MOD2024/0079

PROJECT
 28 Lockwood avenue,
 BELROSE
 NSW 2085

DRAWING
 Lower ground floor plan

DATE	MAR 2024	NORTH	
DRAWN	JS	CHECK	NL
SCALE	1:200 @A1 Sheet Size		
DWG NO.	DA-104	ISSUE	4
STATUS	ISSUE FOR SECTION 4.55	JOB NO.

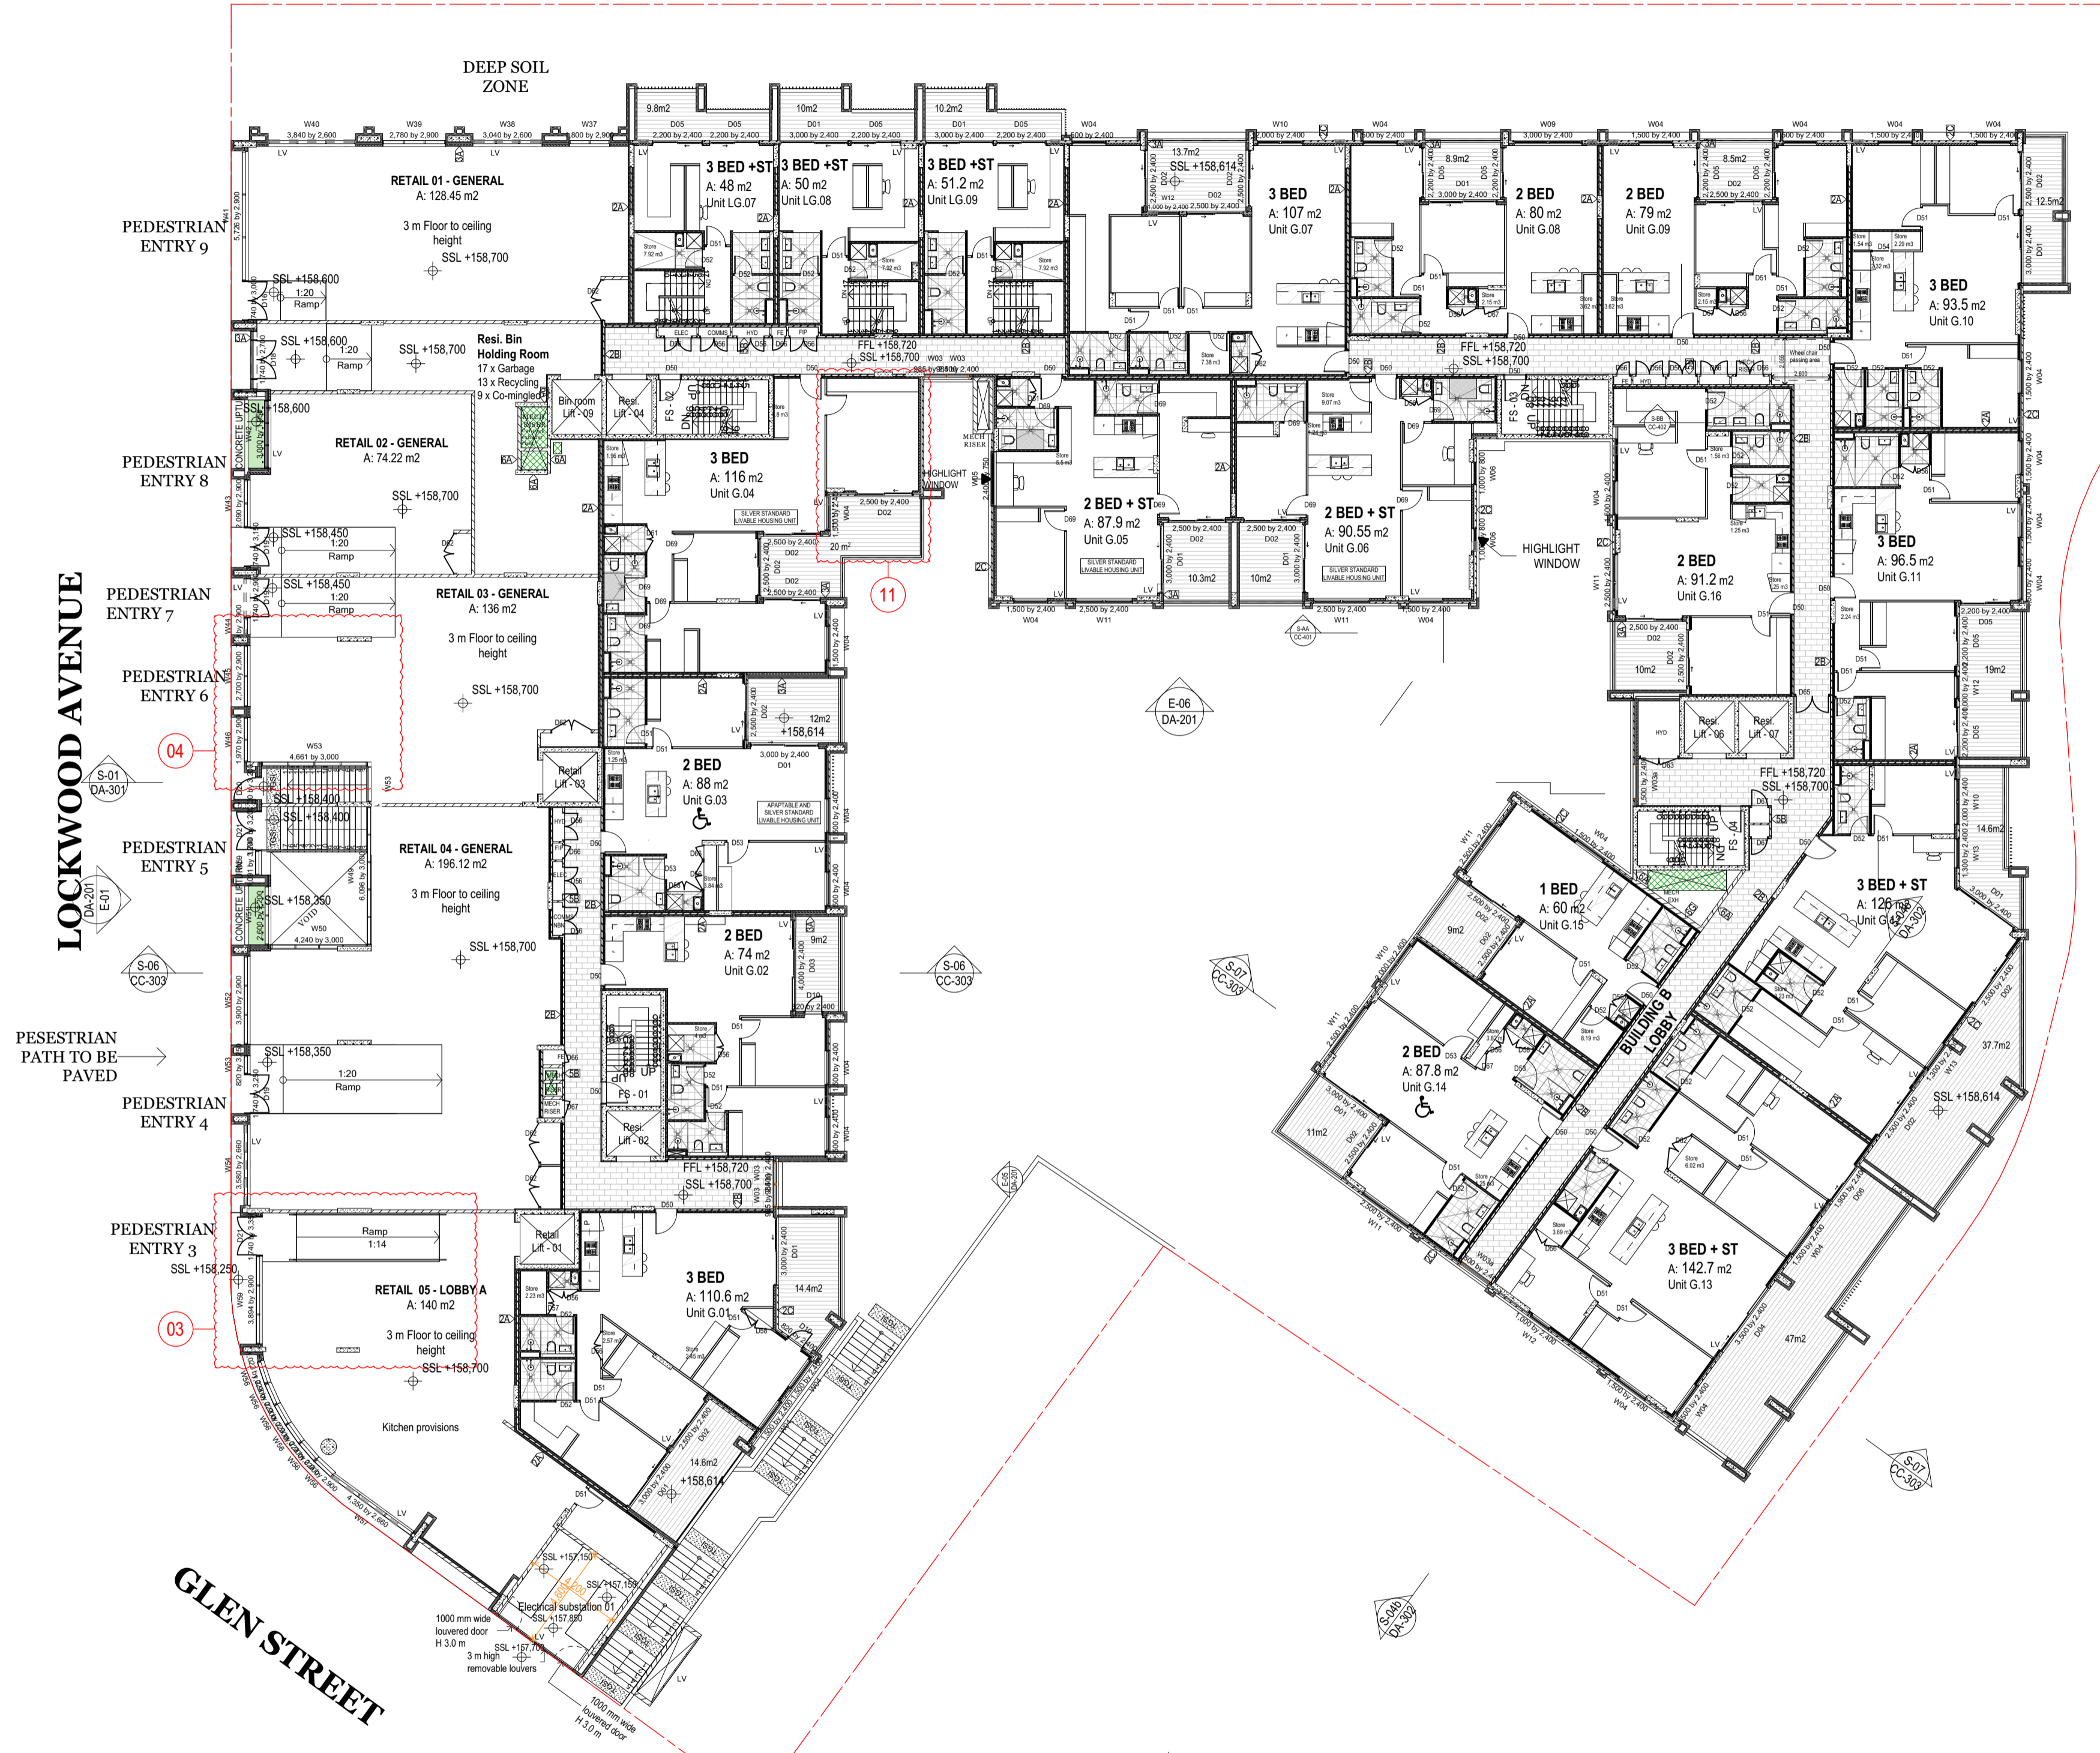
- 4- The void space which is adjacent to retail 03 on ground floor level has been removed and that space has been allocated to retail 03.
- 5- Highlight windows W66, W67 and W68 have been added to retail 03 and retail 05 on lower ground floor to bring natural light into the retail.

- 6- Unit LG12: The internal storage has been relocated to either sides of the TV unit, replaced with a powder room with minor adjustments to the layout of the unit.

- 7- Unit LG13: The internal storage has been relocated to one side of the TV unit and replaced with a powder room.
- 8- Unit LG04: A third bedroom and a balcony has been added to this unit and the surface area of this unit has increase by 20.58 m2. The entry to this unit has been shifted away from lift 05 overrun, since the lift overrun extrudes 600 mm over the SSL of lower ground floor. This change is crucial for lift 05 to work.

- 9- Unit LG01: The external wall of the living room has been pushed out 500 mm to improve the internal layout of the unit.
- 10- Unit 1.12: The external north facing wall has been pushed out 2300 mm to improve the internal layout of the unit and its area has increased by 18.6 m2.

DRAWING
ELEVATIONS

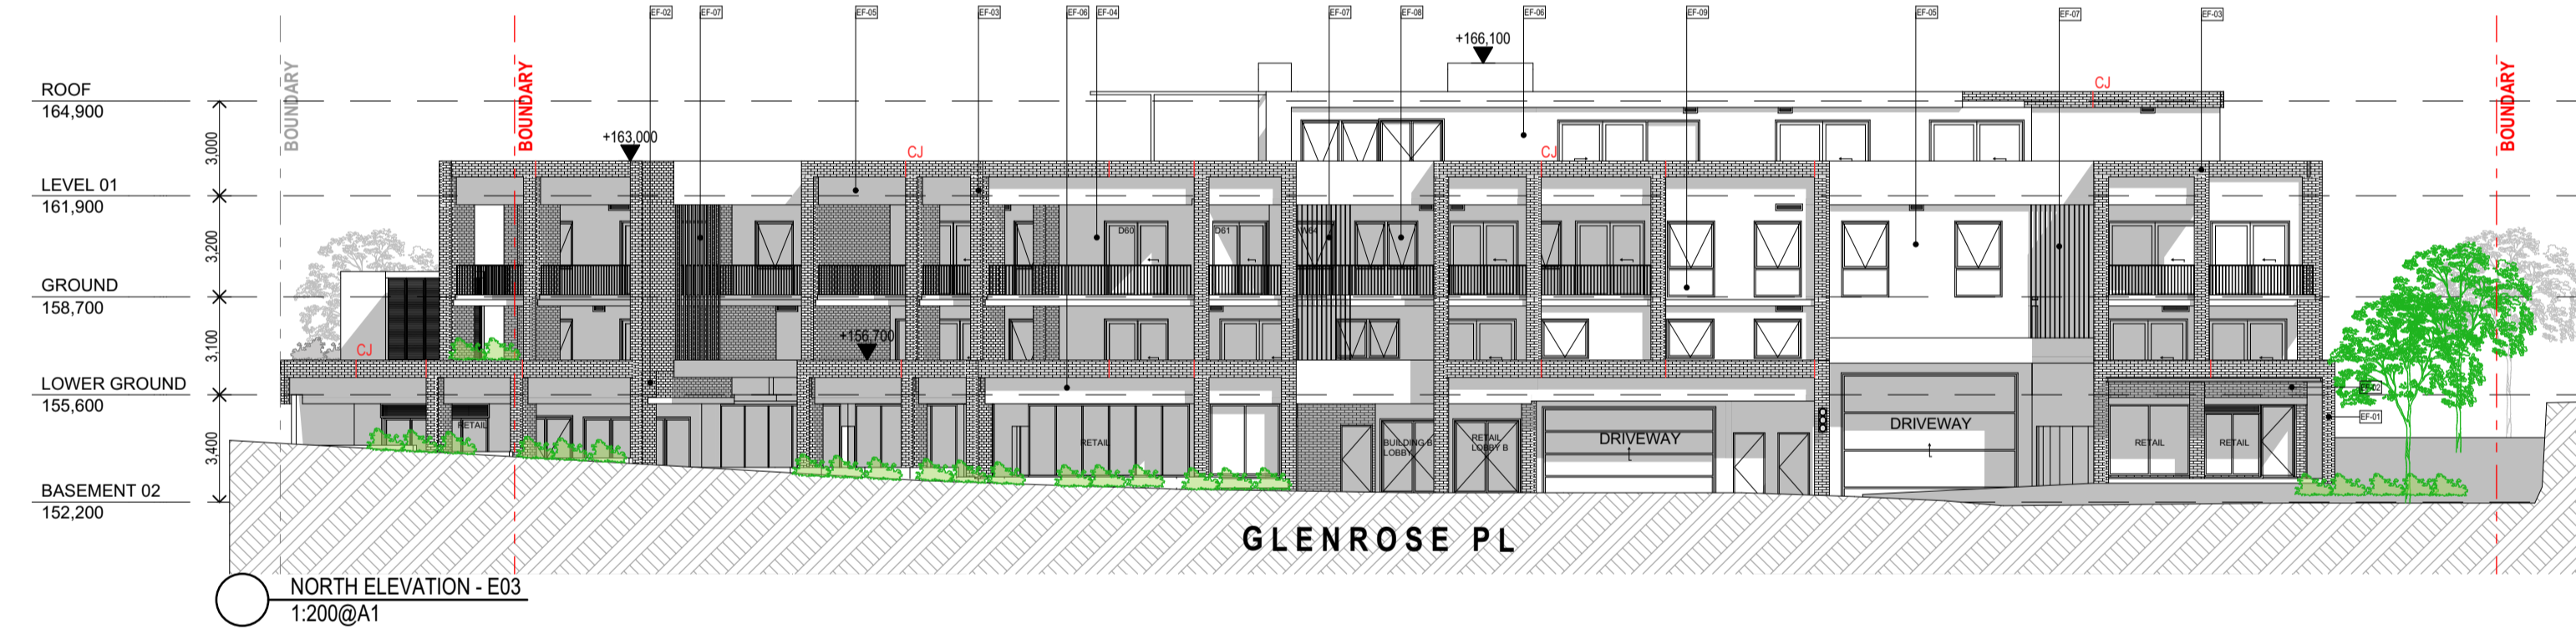
- 1- (Deleted).
- 2- EF-04, EF-05 & EF-06: the "painted concrete" is replaced with "render paint" as specified in the legend of the schedule of finishes.

- 3- Retail 05 - on ground floor level: The external wide entry ramp to retail 05 has been enclosed to be an internal space within the shop with a narrower internal ramp.

- 4- The void space which is adjacent to retail 03 on ground floor level has been removed and that space has been allocated to retail 03.
- 5- Highlight windows W66, W67 and W68 have been added to retail 03 and retail 05 on lower ground floor to bring natural light into the retail.

- 11- Unit G04: A third bedroom and a balcony has been added to this unit and the surface area of this unit has increase by 20.73 m2.
- 12- Unit L1.04: The surface area of this unit has increase by 18.63 m2. The internal layout has been amended and an additional balcony is proposed.

- 13- The roof is extended over the new extension of unit L1.04.
- 14- Unit L1.11: internal amendments to floor plan to avoid drainage of bathrooms inside lift 01 overrun below.

DRAWING
ELEVATIONS

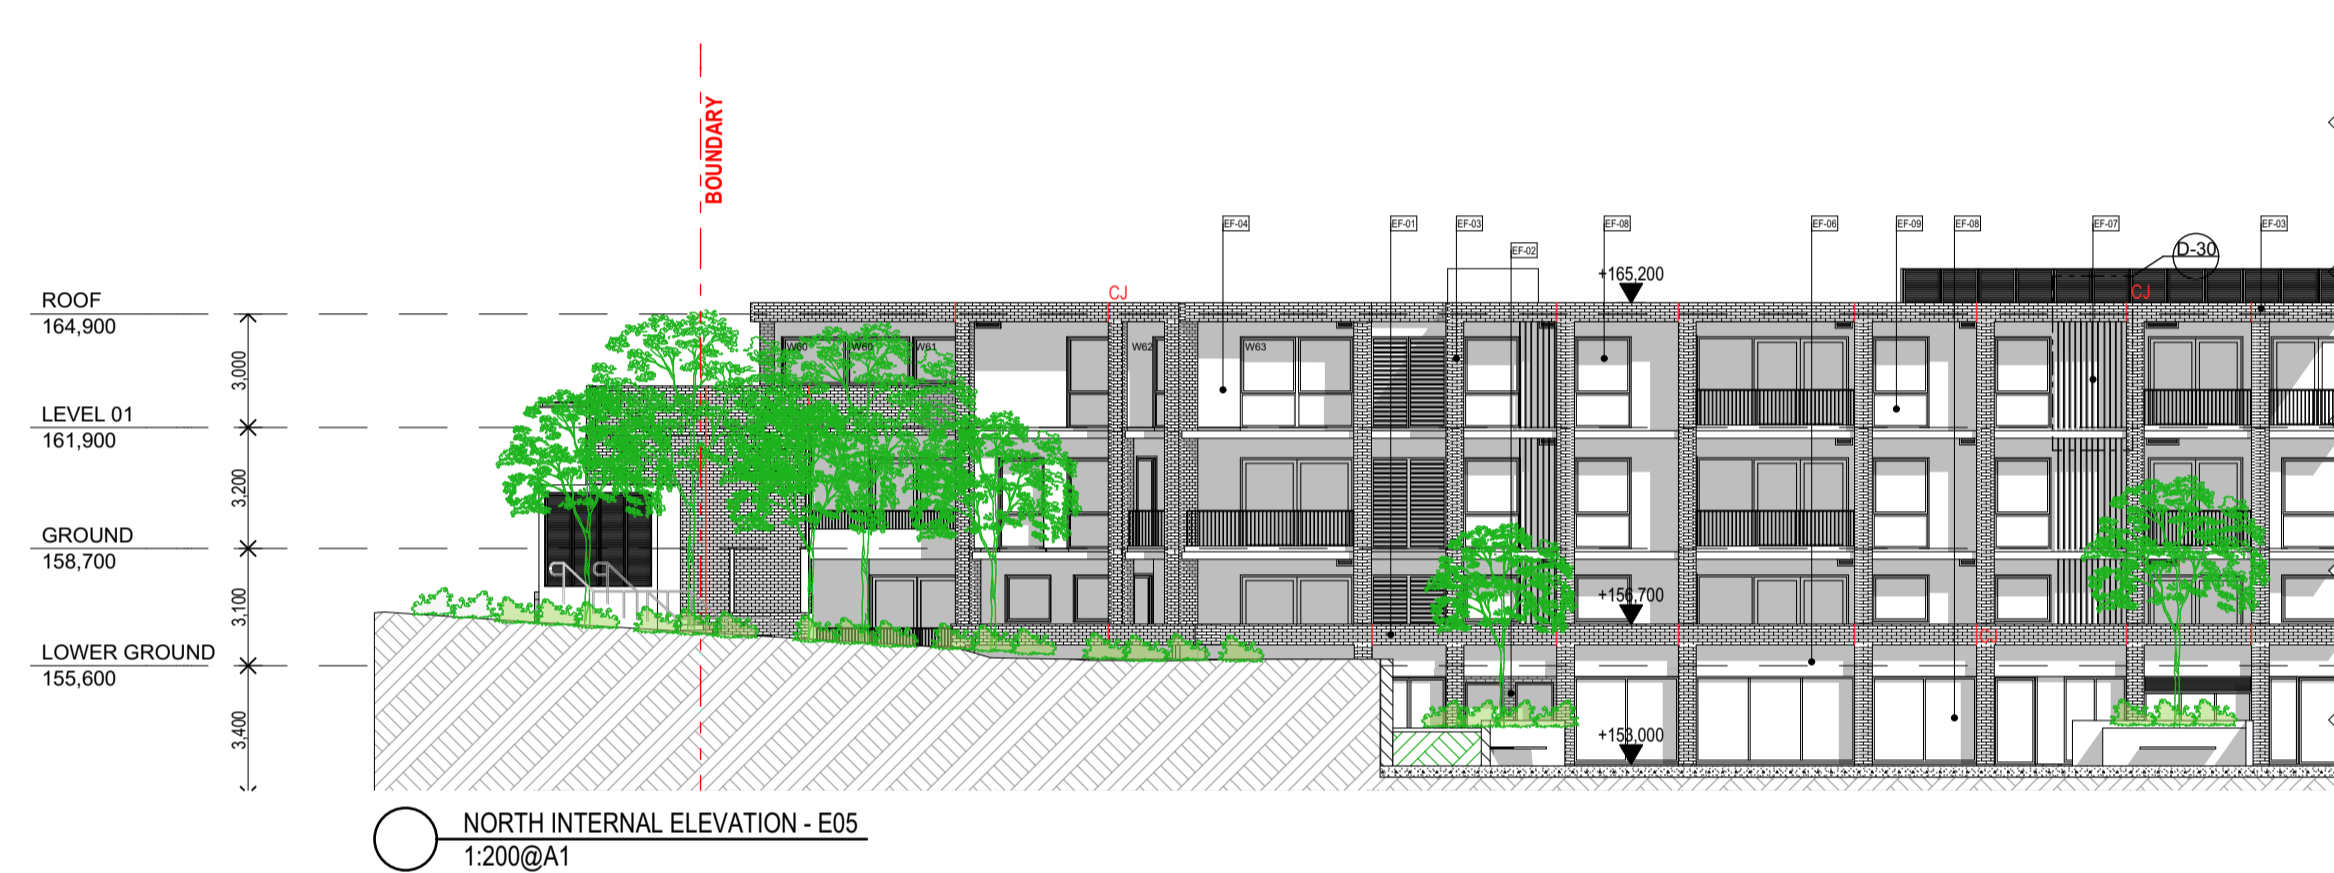
- 1- (Deleted).
- 2- EF-04, EF-05 & EF-06: the "painted concrete" is replaced with "render paint" as specified in the legend of the schedule of finishes.

- 3- Retail 05 - on ground floor level: The external wide entry ramp to retail 05 has been enclosed to be an internal space within the shop with a narrower internal ramp.

- 4- The void space which is adjacent to retail 03 on ground floor level has been removed and that space has been allocated to retail 03.
- 5- Highlight windows W66, W67 and W68 have been added to retail 03 and retail 05 on lower ground floor to bring natural light into the retail.

- 11- Unit G04: A third bedroom and a balcony has been added to this unit and the surface area of this unit has increase by 20.73 m2.
- 12- Unit L1.04: The surface area of this unit has increase by 18.63 m2. The internal layout has been amended and an additional balcony is proposed.

- 13- The roof is extended over the new extension of unit L1.04.
- 14- Unit L1.11: internal amendments to floor plan to avoid drainage of bathrooms inside lift 01 overrun below.

DRAWING
SECTIONS

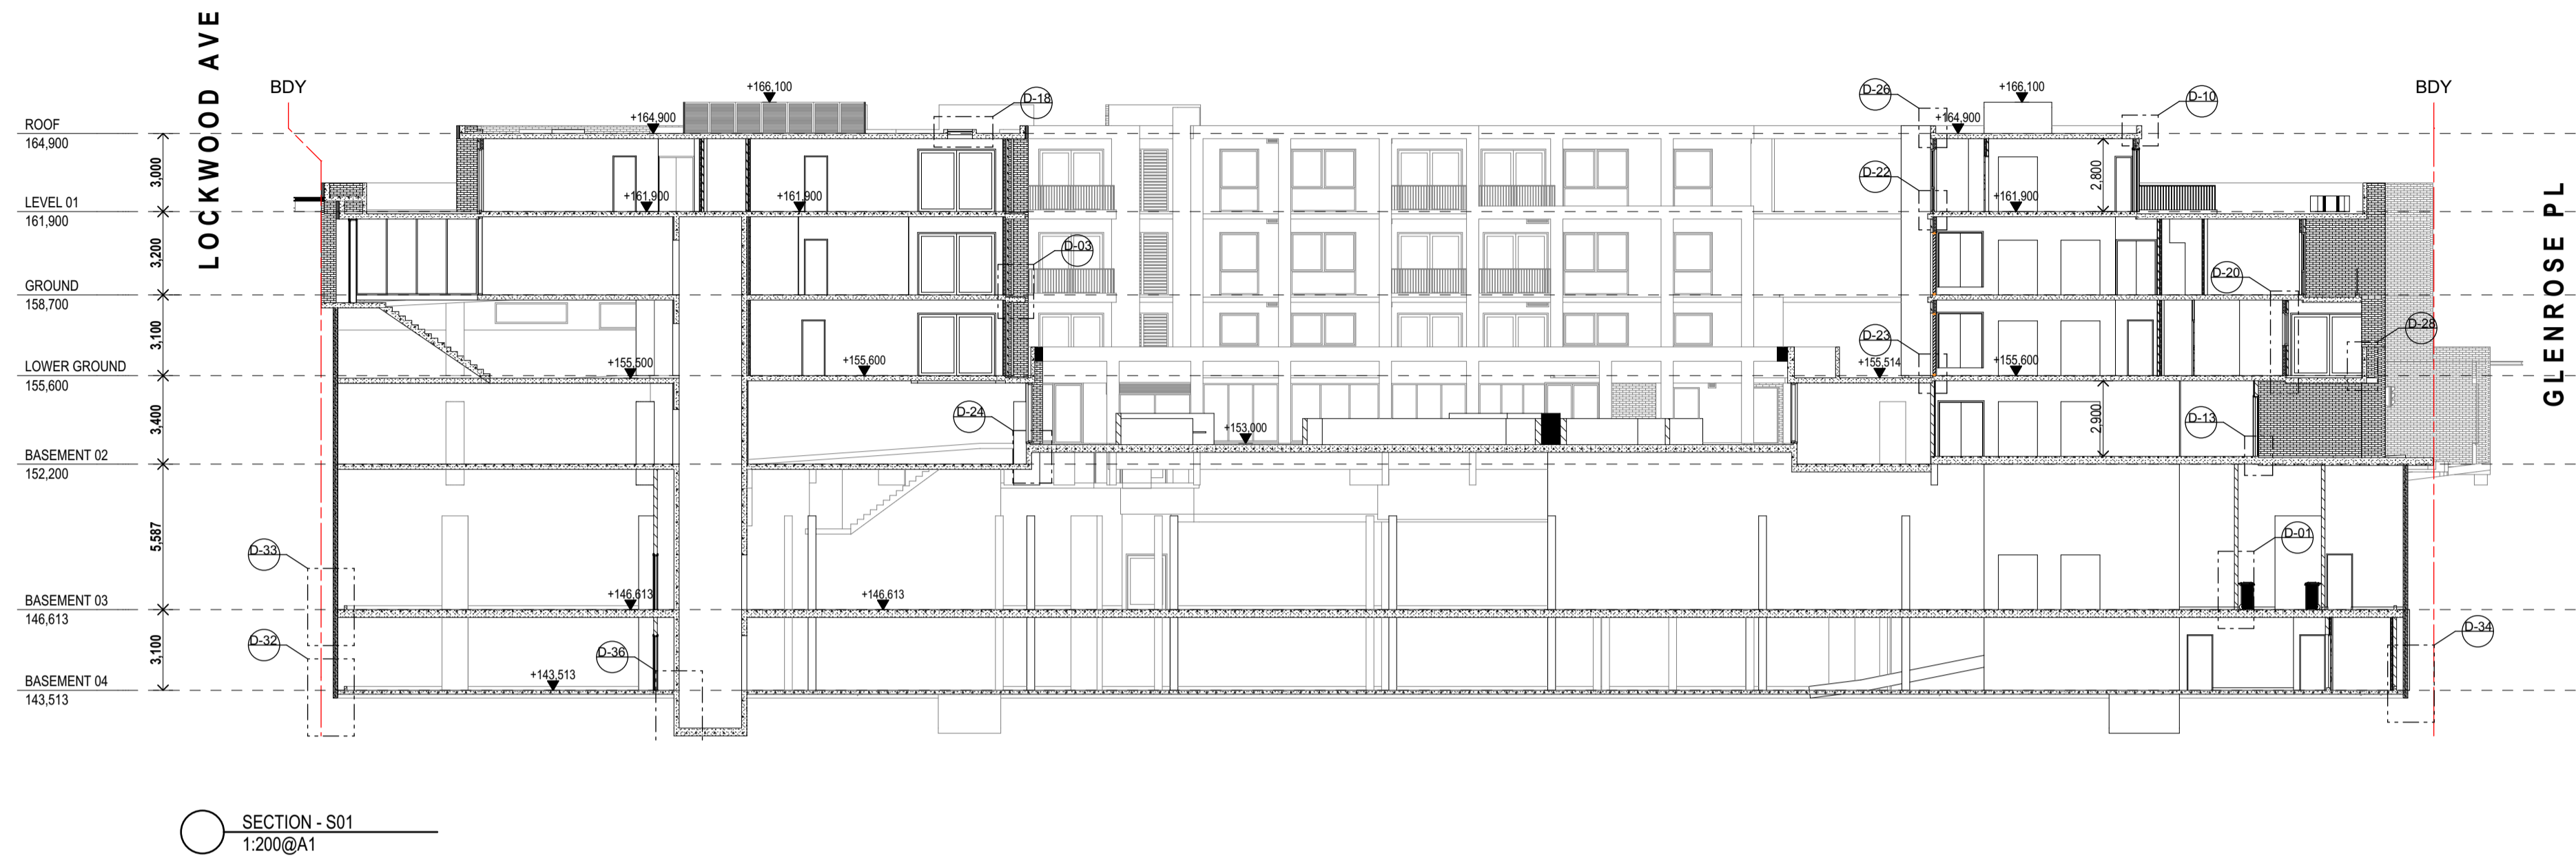
- 1- (Deleted).
- 2- EF-04, EF-05 & EF-06: the "painted concrete" is replaced with "render paint" as specified in the legend of the schedule of finishes.

- 3- Retail 05 - on ground floor level: The external wide entry ramp to retail 05 has been enclosed to be an internal space within the shop with a narrower internal ramp.

- 4- The void space which is adjacent to retail 03 on ground floor level has been removed and that space has been allocated to retail 03.
- 5- Highlight windows W66, W67 and W68 have been added to retail 03 and retail 05 on lower ground floor to bring natural light into the retail.

- 11- Unit G04: A third bedroom and a balcony has been added to this unit and the surface area of this unit has increase by 20.73 m2.
- 12- Unit L1.04: The surface area of this unit has increase by 18.63 m2. The internal layout is being amended and an additional balcony is proposed.

- 13- The roof is extended over the new extension of unit L1.04.
- 14- Unit L1.11: internal amendments to floor plan to avoid drainage of bathrooms inside lift 01 overrun below.
